Planning & Zoning Board

Thursday, January 16, 2025

1. App# 2024-0630; 2467 Taylor Square Dr.; Kush Patel for 256 Hotel Group, LLC; Variance
2. App# 2024-0629; 2467 Taylor Square Dr.; Kush Patel for 256 Hotel Group, LLC; Conditional Use

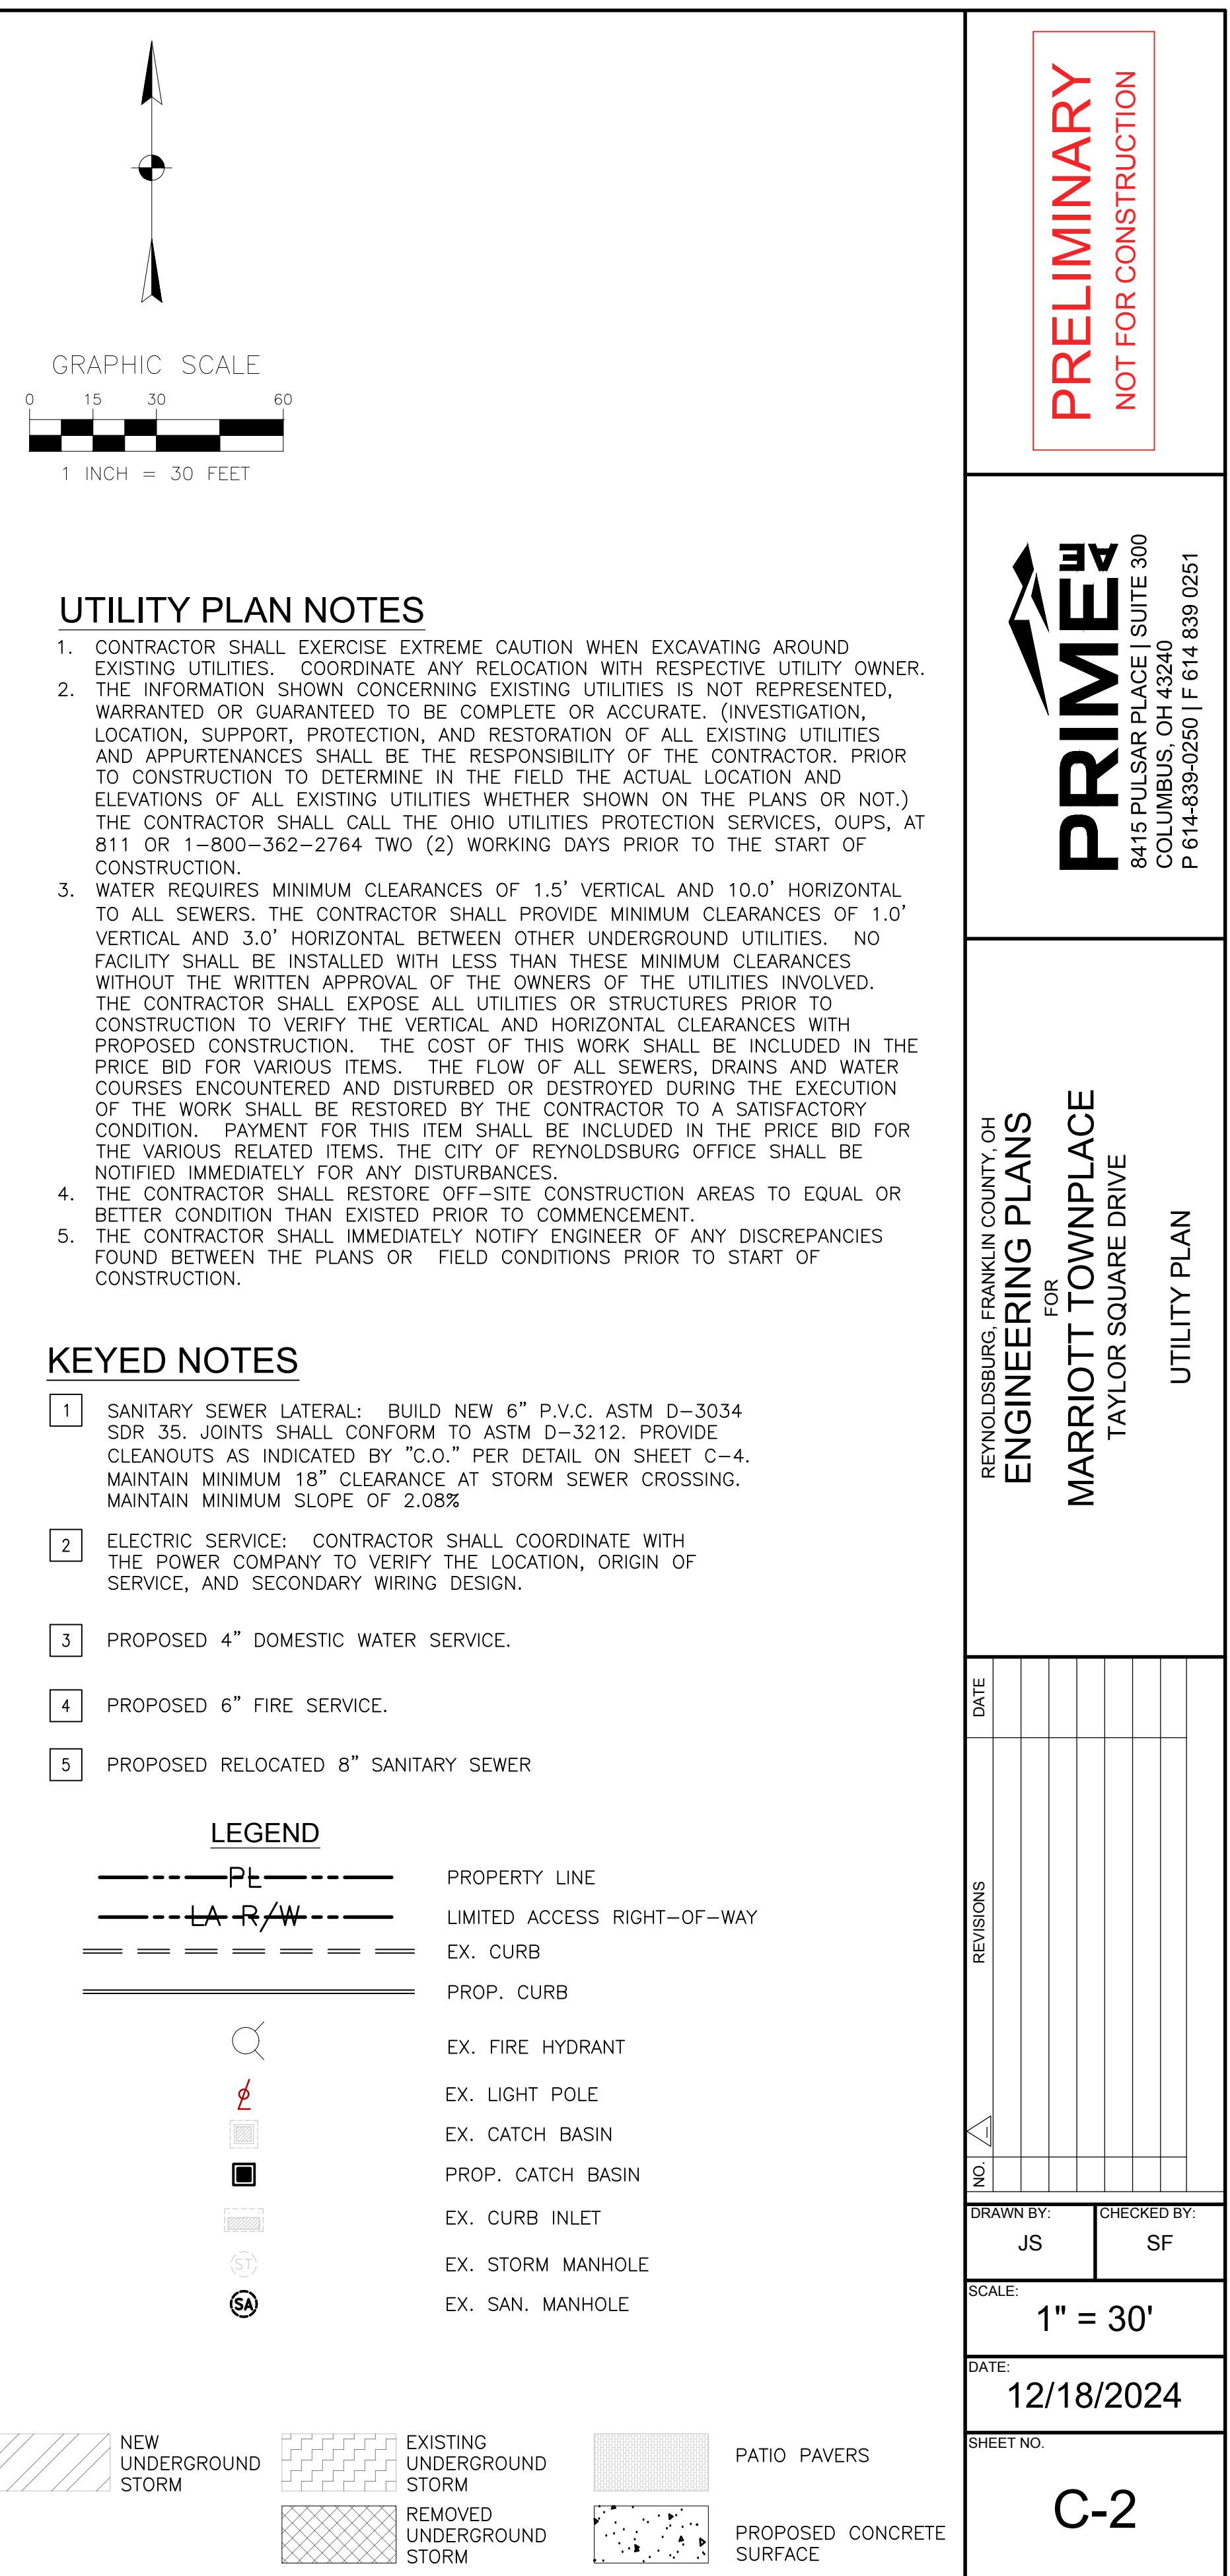
- a. The applicant has since provided a revised landscape plan, which shows the required 11 parking lot landscape islands.
 - 1. The required number of parking lot landscape islands has been met.
